Amendments to the Drawings:

Remarks:

Applic. No. 10/539,837
Response Dated July 29, 2008
Responsive to Office Action of April 29, 2008

FIG. 7

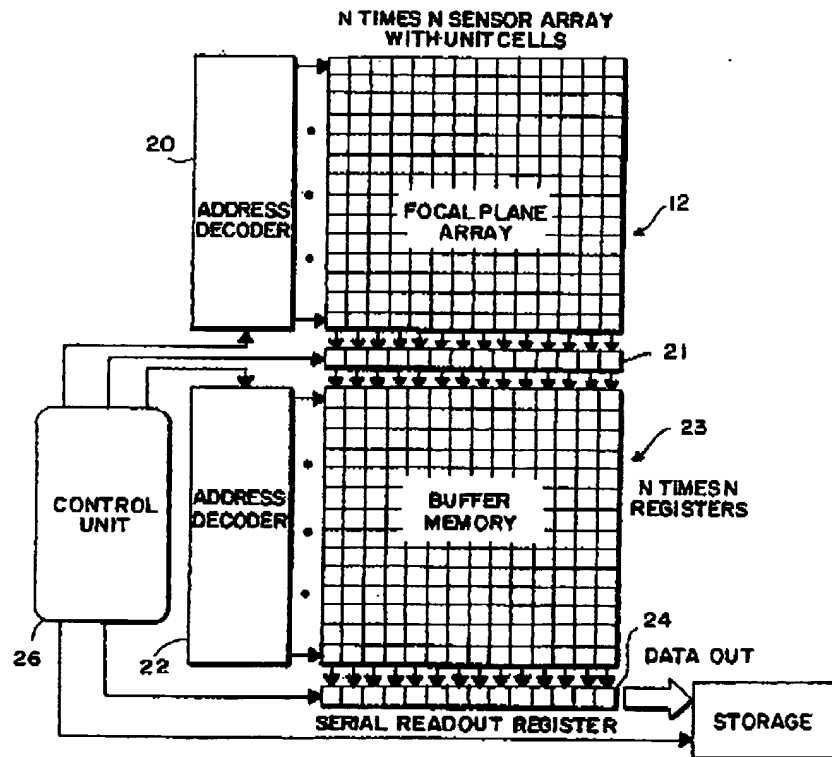
As can be seen, the Office Action did not, separately, point out where in the references Applicants' particularly claimed data processing unit, internal to each readout cell, could be found. Rather, item 10 of the Office Action referred back to the rejection of Applicants' former claim 1. Page 7 of the Office Action points to the "control unit" of Fig. 7 of FOSSUM1, as allegedly showing the claimed "data processing

means" of Applicants' former claim 1. However, as can be seen, more particularly, from Fig. 7 of FOSSUM1, the control unit (26 of Fig. 7 of FOSSUM1) is not internal to each readout unit cell, but instead, is external to the entire buffer memory. Fig. 7 of FOSSUM1, illustrating the control unit 26 being external to all of the readout cells, is reproduced herebelow, for convenience.

FIG.3

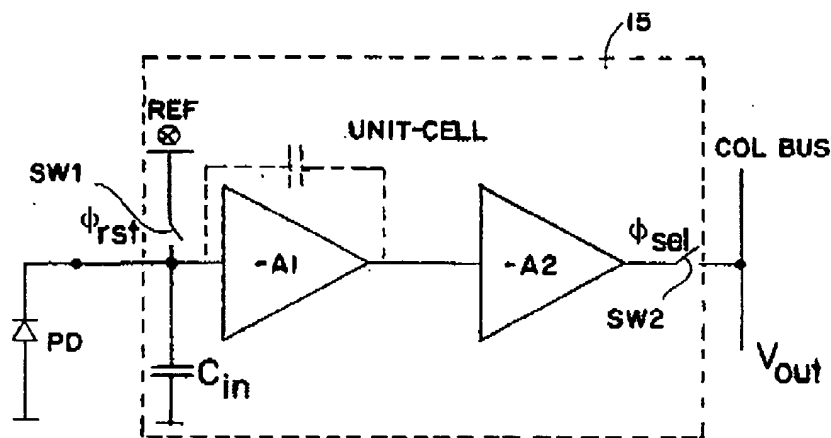
Fig. 3 of FOSSUM1 shows a basic schematic diagram of a "unit cell" for one photodetector diode of the solid state array which is connected between a photovoltaic type of

photodetector diode and a column bus for readout. As can be seen from FIG. 3 of FOSSUM1, the "unit cell" 15 of Fig. 3 of FOSSUM1 does not include an internal data processing unit. Fig. 3 of FOSSUM1 is additionally being reproduced herebelow, for convenience.

See also, for example, col. 6 of FOSSUM1, line 50 - col. 7, line 62, describing the unit cell of Fig. 3 of FOSSUM1. Thus, among other limitations of Applicants' claims, the FOSSUM1 reference fails to teach or suggest each readout cell including an internal data processing unit, as required by Applicants' claim 44. The MOULSLEY and GRUSS references, cited in item 10 of the Office Action in combination with FOSSUM1 against Applicants' former claim 19 (current claim 44), do not cure the above discussed deficiencies of the FOSSUM1 reference.

Applic. No. 10/539,837
Reply to Office Action dated 04/29/2008
Amendment dated 07/29/2008
Annotated Sheet

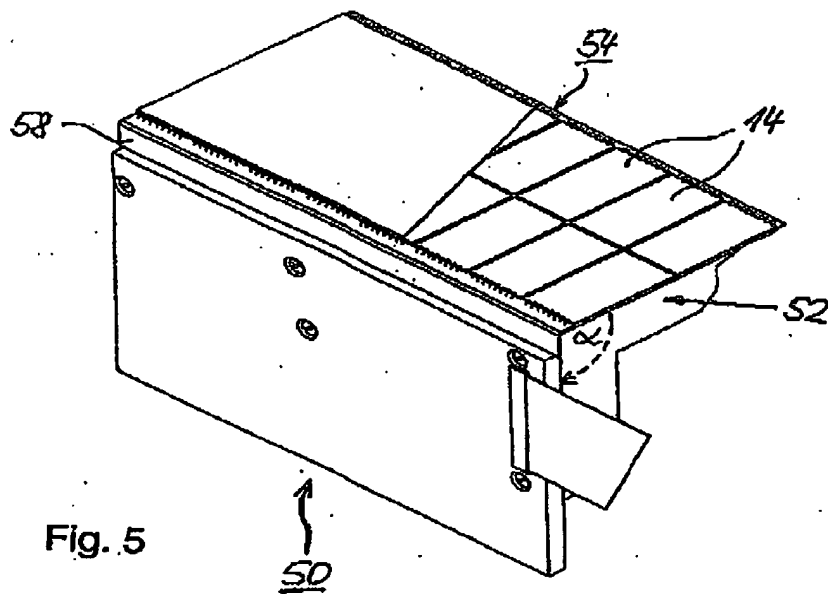
Additionally, in Fig. 4, the word "TRESHOLD" was changed to "THRESHOLD" and the phrase "GLOBAL TRESH" was changed to "GLOBAL THRESH". In Fig. 8A, " V_{THRES} " was changed to " V_{THRESH} ".
